ADDENDUM No. 1

RFP No. 23-10

Research Park Drive Resurfacing Project

Know what's below. Call before you dig.

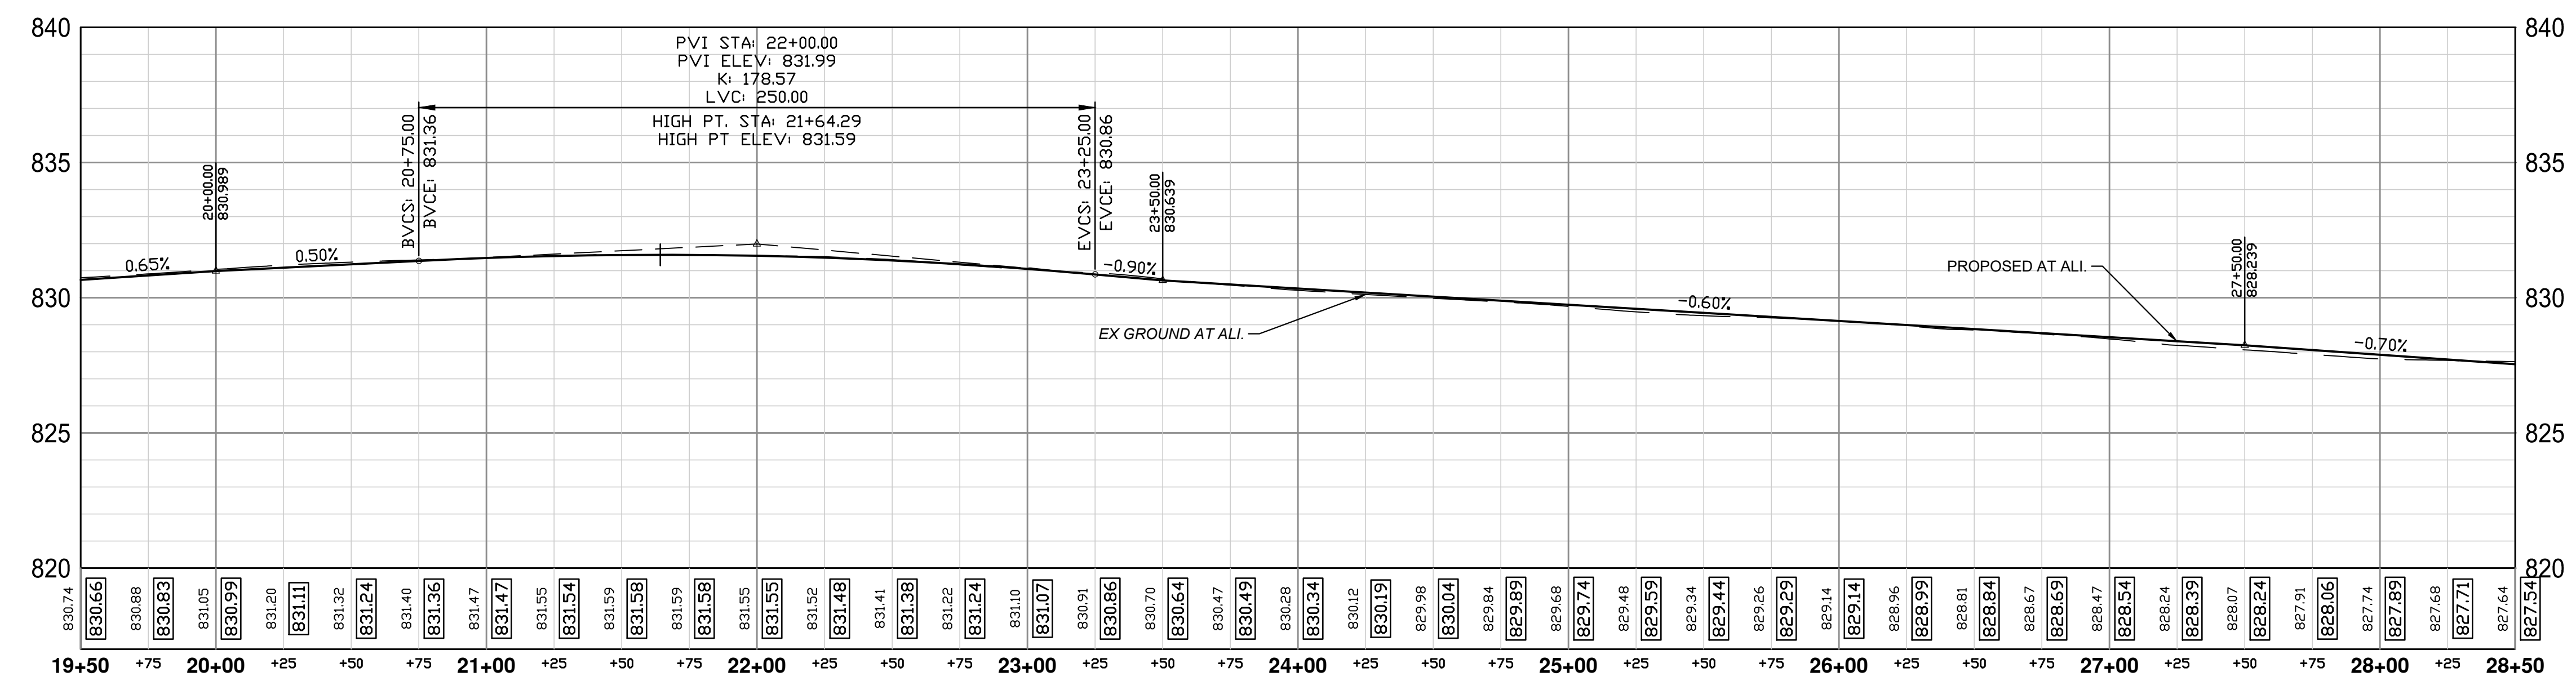
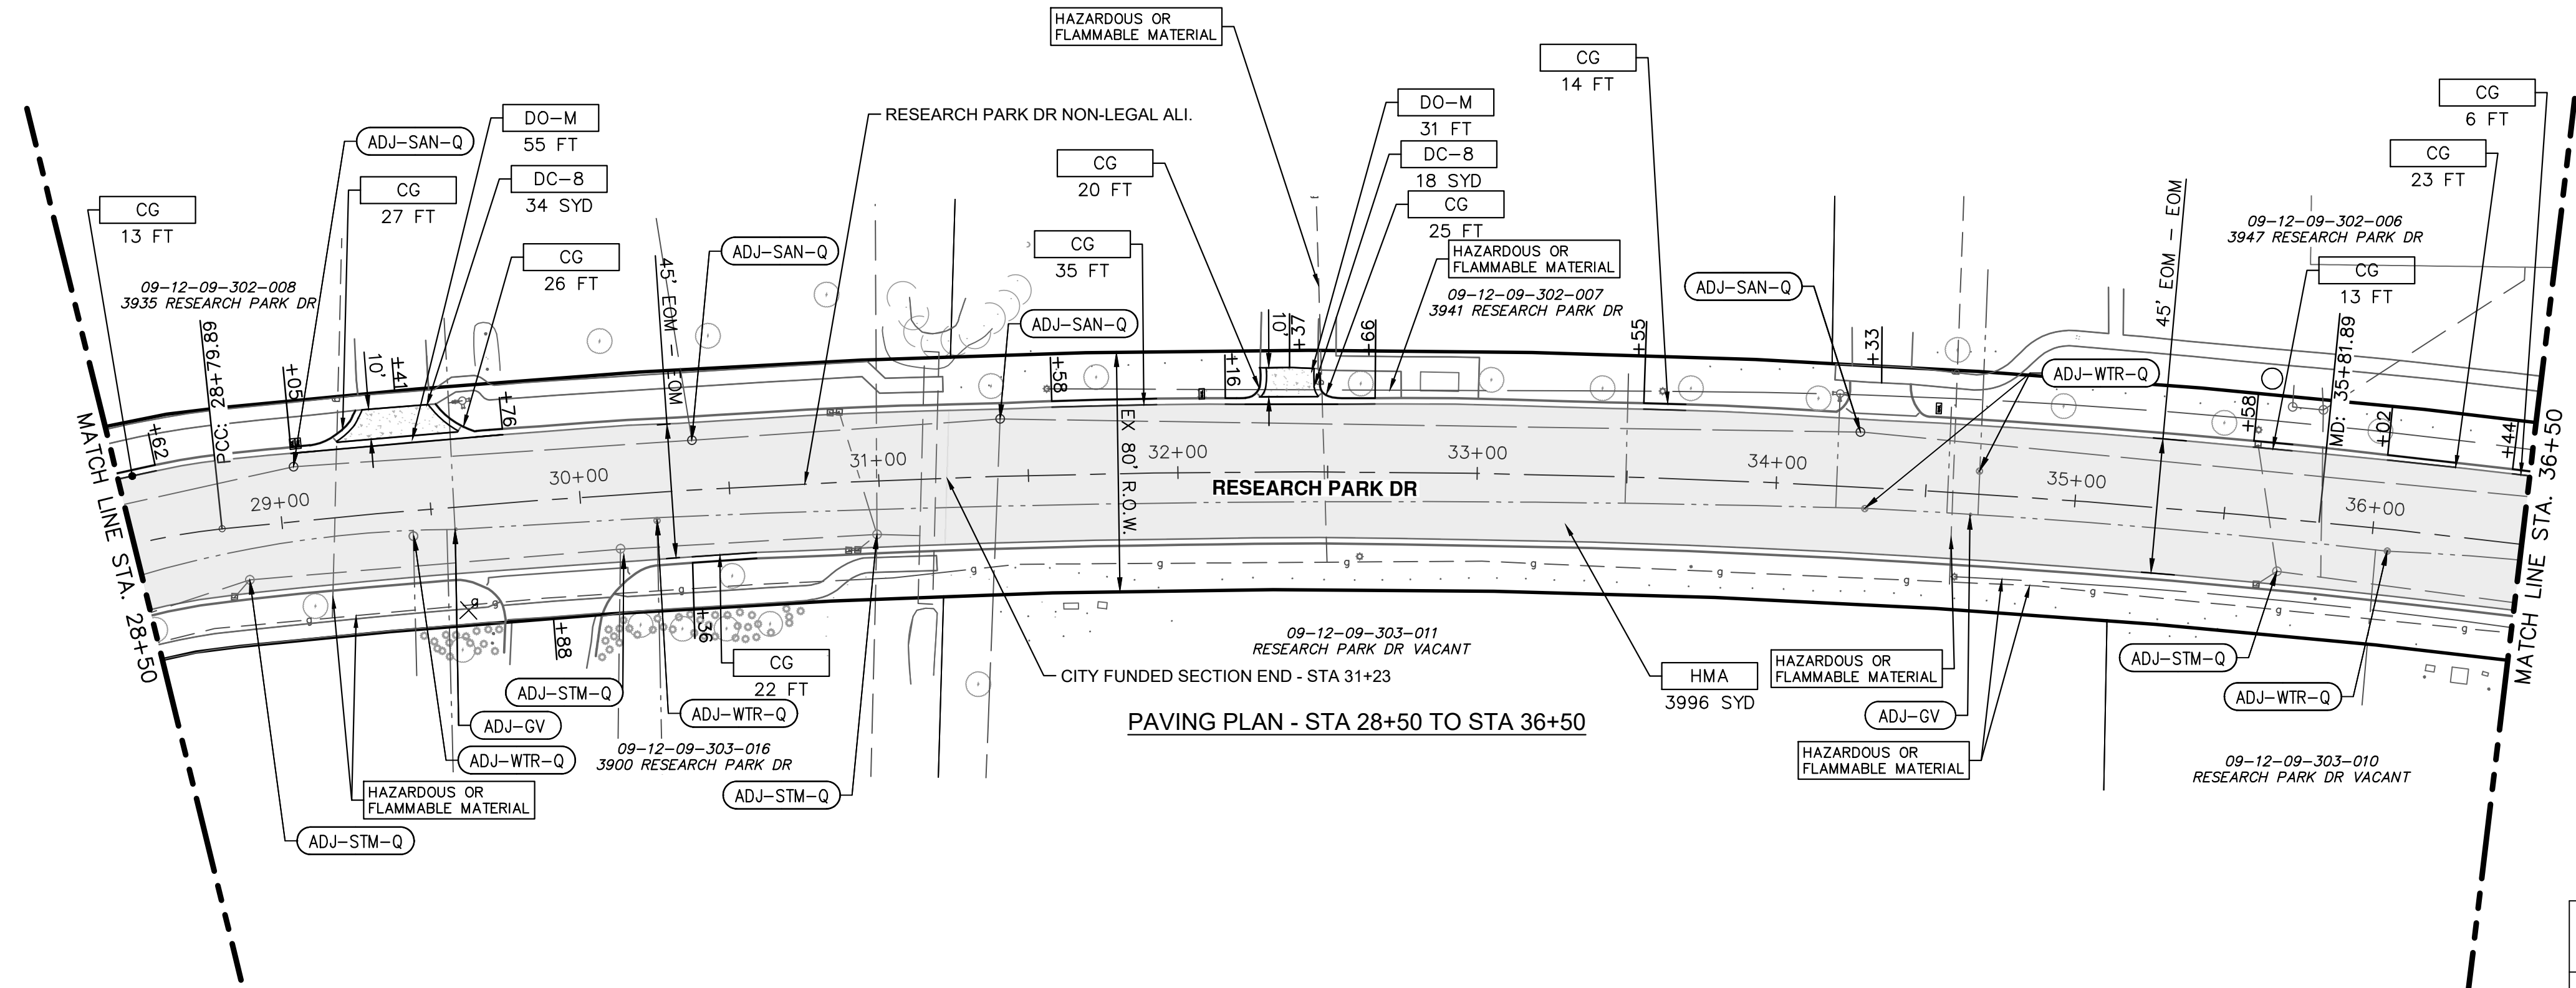
Sheet 9	Revised call outs on proposed typical section related to hot mix asphalt leveling and top courses. Revised HMA Application Table
Sheets 10-13	Revised call outs on proposed typical sections related to hot mix asphalt leveling and top courses.
Sheets 20-27	Revised call outs related to storm structure covers and adjustments.
